STATE OF NORTH CAROLINA
DEPARTMENT OF TRANSPORTATION

ADDENDUM # 1

RE: **Bidder Concerns and Associated Responses, Revisions to: Availability
Completion Dates, Pay Items, Special Provisions, and Plans**

Contract ID: DN00600

TYPICAL SECTION NO. 1

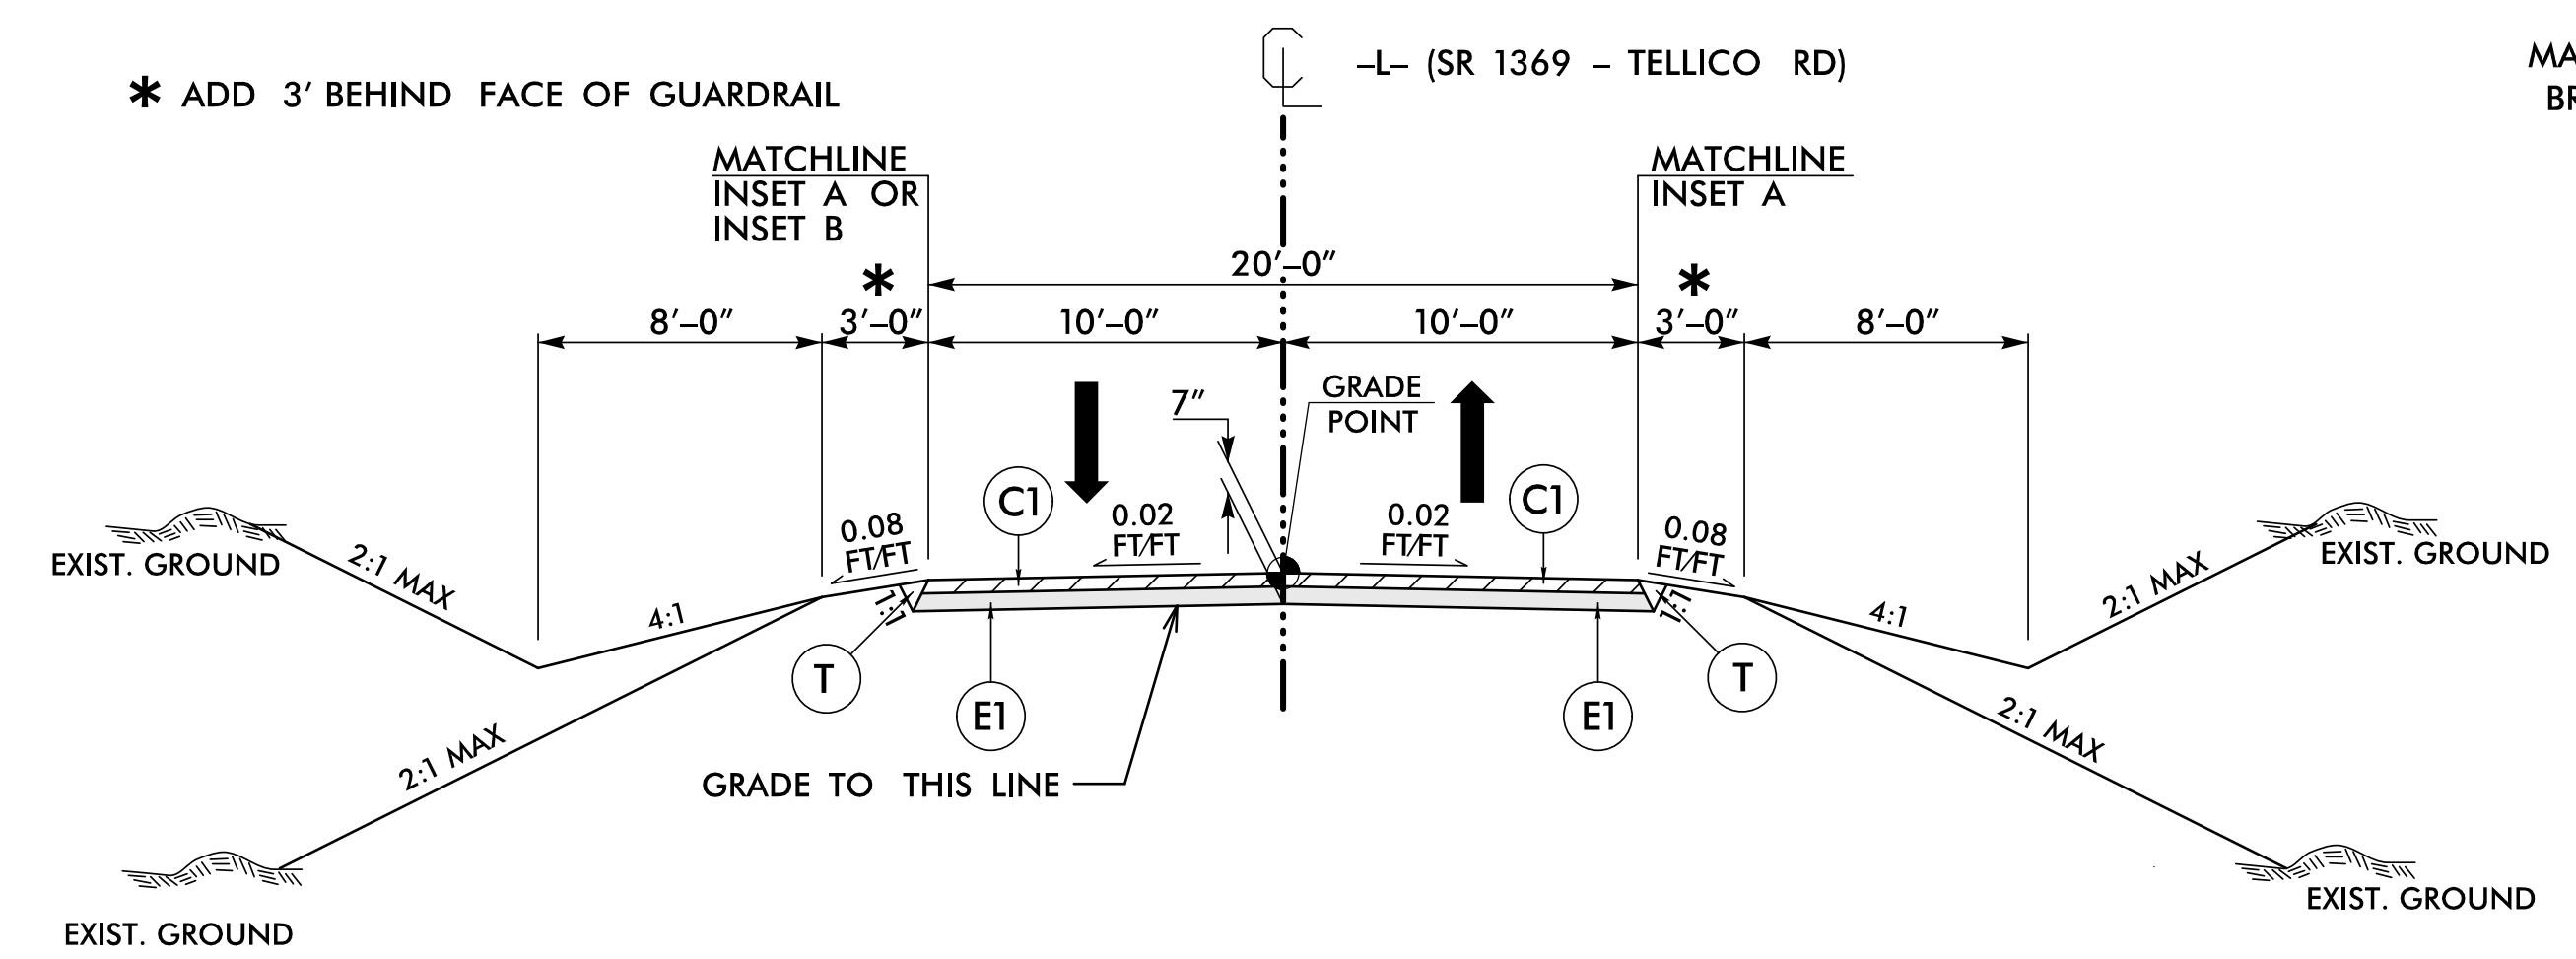
NOTE: ALL GUARDRAIL SHALL BE POWDER COATED DARK BROWN IN COLOR TO MATCH ANODIZED 2-BAR METAL RAIL
